# SERVICE BULLETIN

POWERPLANT — HARNESS CLAMP — REDUCTION OF HARNESS CLAMP  
SIZE REQUIREMENT AT CLIPPING POINT 2409

V2500 Series 71-0319

**V2500-ENG-71-0319**

LOCATION OF CLIPPING POINT 2409  
FIGURE 1

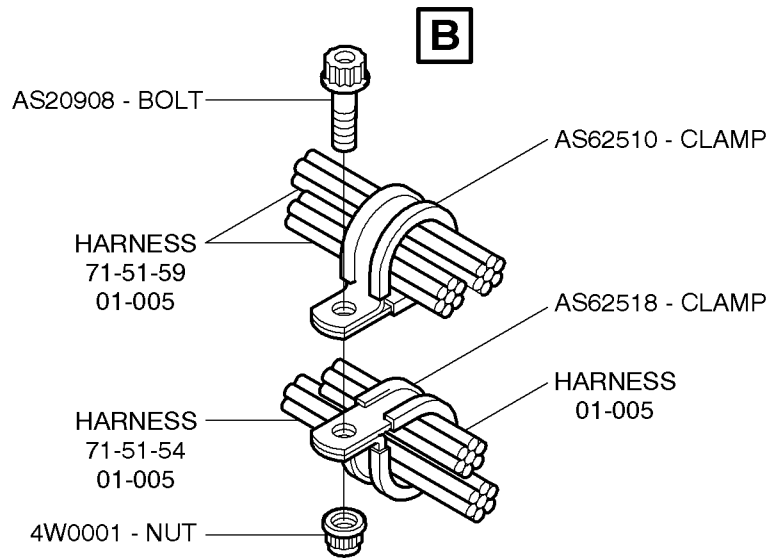
1. Open thrust reverser halves in accordance with Reference 5, Aircraft Maintenance Manual (AMM), Task 78-32-00.
2. Remove the Nut, PN 4W0001 and the Bolt, PN AS20908 which attach the Clamp, PN AS62518 and PN AS62510 at clipping point 2409. See Figures 1 and 2 for location of the parts.

DETAILS OF CLIPPING POINT 2409  
FIGURE 2

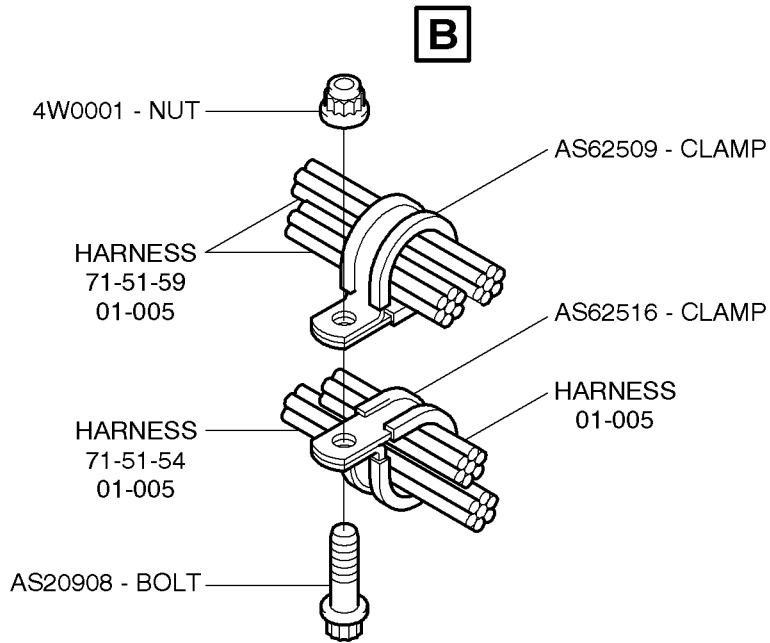
The purpose of this Service Bulletin is to replace the harness clamps at clipping point 2409 with a smaller size to prevent relative movement which might lead to chafing of an adjacent oil line.

1. Condition: Loss of oil and low oil pressure was attributed to a chafed Oil Scavenge Tube, PN 6A5089 adjacent to clipping point 2409. Chafing was caused by the bolt attached to clipping point 2409 when clamps moved along the harness.
2. Background: An In-Flight Shutdown (IFSD) occurred in service due to loss of oil quantity and low oil pressure. Loss of oil was due to chafing of a bolt causing a hole to the Oil Scavenge Tube, PN 6A5089 at clipping point 2409.
3. Objective: Provide instructions to replace the clamps.
4. Substantiation: Investigation showed that chafing of the oil tube can be avoided by installing smaller clamps.
5. Effects of Bulletin on:
  - Removal/Installation: Affected.
  - Disassembly/Assembly: Not Applicable.
  - Cleaning: Not Applicable.
  - Inspection/Check: Affected.
  - Repair: Not Applicable.
  - Testing: Not Applicable.
6. Supplemental Information
  - None.

3. Remove the Clamp, PN AS62518 and PN AS62510.
4. Obtain the new Clamps, PN AS62516 and PN AS62509.
  - A. Replace Clamp, PN AS62518 with Clamp, PN AS62516.

- B. Replace Clamp, PN AS62510 with Clamp, PN AS62509.
5. Install the new Clamp, PN AS62516 and PN AS62509, Bolt, PN AS20908 with shaft showing upwards (see Figure 2) and Nut, PN 4W0001 at clipping point 2409 in accordance with Reference 2, Standard Practices Manual (SPM), Task 70-43-02-400-501. Torque the Nut, PN 4W0001 to 36 – 45 lbf-in. (4 – 5 N-m).
